69-73 READ STREET

RE: 69-73 Read Street  
Assessor Map - 141-J-B

CITY OF PORTLAND, MAINE  
Department of Building Inspection

69-73 READ ST. +  
TOTAL AREA - 47,550 SQ. FT. (APP)

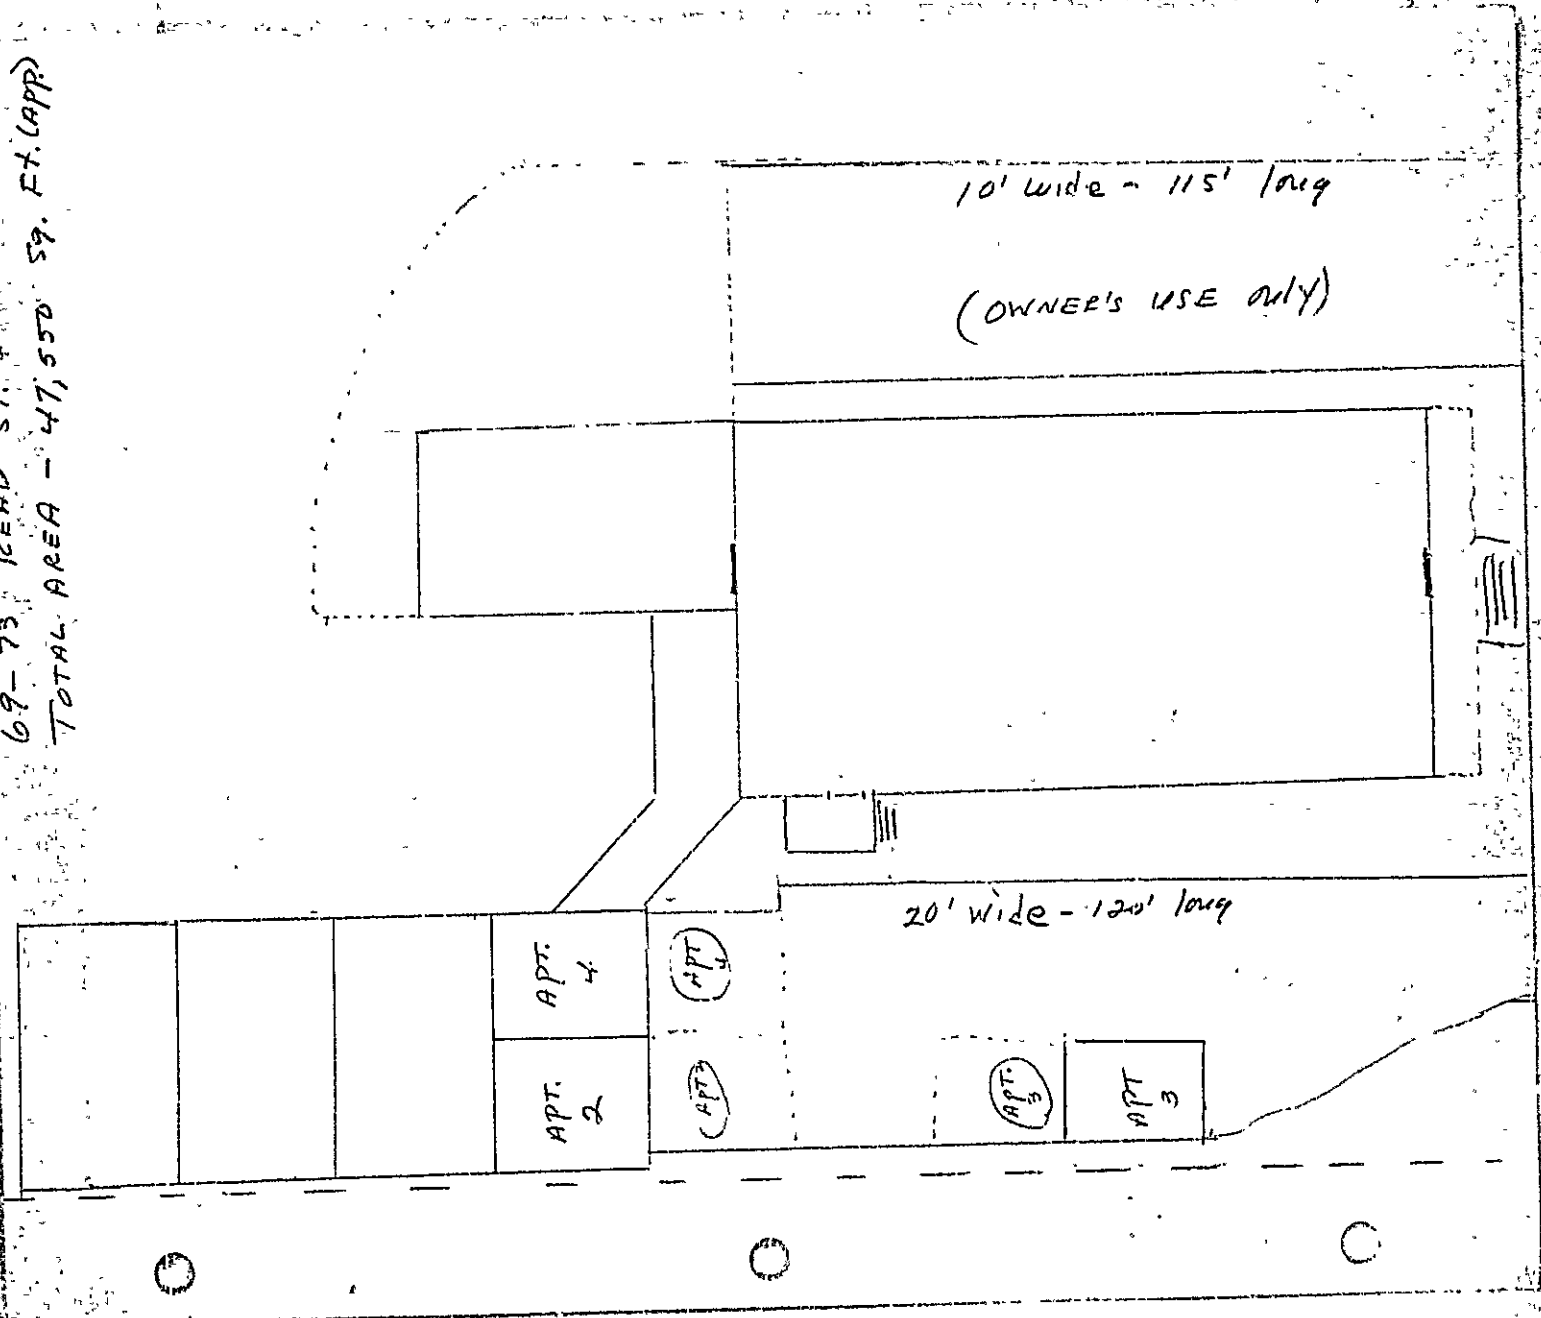
It has come to the attention of this department that there has been a change of use at this property from 3-family to 4-family said to be owned by you.

Our records show that no one has applied for a building permit, or plumbing, or electrical.

It is necessary that someone apply for permits within 10 days, not later than April 28th, 78. A plot plan and floor plans should be submitted with the application. The plot plan should show the off-street parking area, the floor plan must show the location of exits and the complete floor layout, etc.

↙ Pump House at 71 Read Street

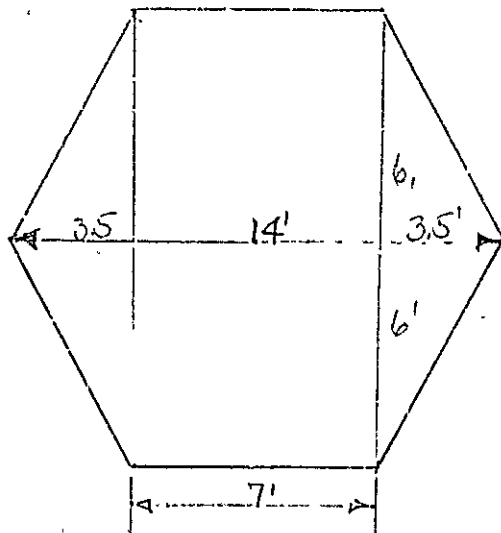
1. The 4x4 sills are below the minimum size of 4x6 specified by Section 312-C-3 of the Code and besides do not figure out to carry the theoretical load that may come upon them.

3. The roof has no rafters and depends entirely upon arching action of the domed shaped construction. It is doubtful that this construction will provide the live load capacity of at least 40 pounds per square foot required by Section 306-a- of the Ordinance and can be accepted only if the adequacy of its strength can be demonstrated according to the usual methods of engineering design.

2. To strengthen and stiffen the single plate at top of exterior walls and the single header over each window, diagonal 2x3's will be cut in between plate and header, bevelled as necessary, in the two spaces above each side over each window--these are the end spaces of the three over each window, formed by two pieces of blocking between header and plate. These diagonals will be nailed securely at every bearing, thus to form a modified truss over each window.

1- Sills: - Wall: -  $6 \times 7 \times 10 = 420^\#$   
Roof: -  $\frac{7}{2} \times 7 \times 4.5 = \frac{1100^\#}{1520^\#}$
